Access Compliance Report

Public Rights-of-Way

(Curb Ramps)

Intersection ID: 12267	Main Street: CENTRAL_AV	Cross Street: LOUISE_AV	Location: W
ADA ID: 94FD7B1E0A5B	Ramp Type: BlendTrans1	Initial Pass/Fail: Fail	Overall Compliance: No
		Severity Score: 8.75

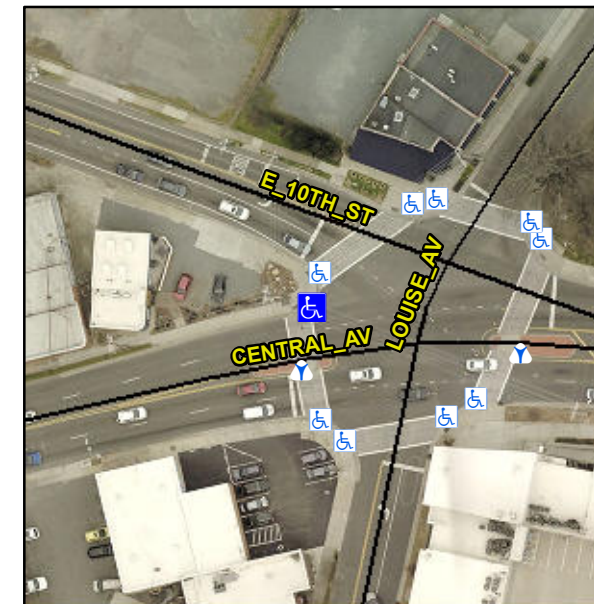
Not Found, R304.5.1

Compliance	Description	Data	Compliance	Description	Data
N/A	Ramp Length (in)	39.5	Yes	BlendTrans Slope (%)	1.7
No	Ramp Width (in)	47.5	Yes	BlendTrans XSlope (%)	1.8
N/A	Flare Type LT	N/A	N/A	Flare Type RT	N/A
N/A	Flare Slope LT (%)	N/A	N/A	Flare Slope RT (%)	N/A
N/A	Flare Traversable LT?	N/A	N/A	Flare Traversable RT?	N/A
N/A	Landing Length (in)	N/A	N/A	DWS Provided?	N/A
N/A	Landing Width (in)	N/A	N/A	DWS Contrast?	N/A
N/A	Landing Slope (%)	N/A	N/A	DWS Length (in)	N/A
N/A	Landing X Slope (%)	N/A	N/A	DWS Full Width?	N/A
N/A	Landing Curb? (Y/N)	N/A	N/A	DWS Offset (in)	N/A
N/A	Shared Landing?	N/A			
N/A	Gutter Ponding?	Yes	N/A	Gutter Slope (%)	N/A
N/A	Gutter Lip Ht (in)	N/A	N/A	Gutter X Slope (%)	N/A
N/A	Painted X Walk1?	Yes	N/A	Painted X Walk2?	N/A
	X Walk 1 Direction	To S		X Walk 2 Direction	N/A
	X Walk 1 Width (in)	144.0		X Walk 2 Width (in)	N/A
	X Walk 1 Slope (%)	2.8		X Walk 2 Slope (%)	N/A
	X Walk 1 X Slope (%)	0.1		X Walk 2 X Slope (%)	N/A

N/A	Ramp inside XWalk1?	Yes	N/A	Ramp inside XWalk2?	N/A
	Road Slope (%)	0.1		Clear Space?	N/A
	Road X Slope (%)	2.8	N/A	Clear Space to XWalk (in)	N/A
N/A	Any Obstructions?	N/A	N/A	Storm Grate/Utility Hazard?	N/A
	Obstruction Type			Storm Grate/Utility Type	
		N/A			N/A
		Yes		Surface Condition? (G/P)	Good
		No		Curb Slope (%)	7.8

Remove & Replace Curb Ramp With Two New Directional Ramps or Equivalent.
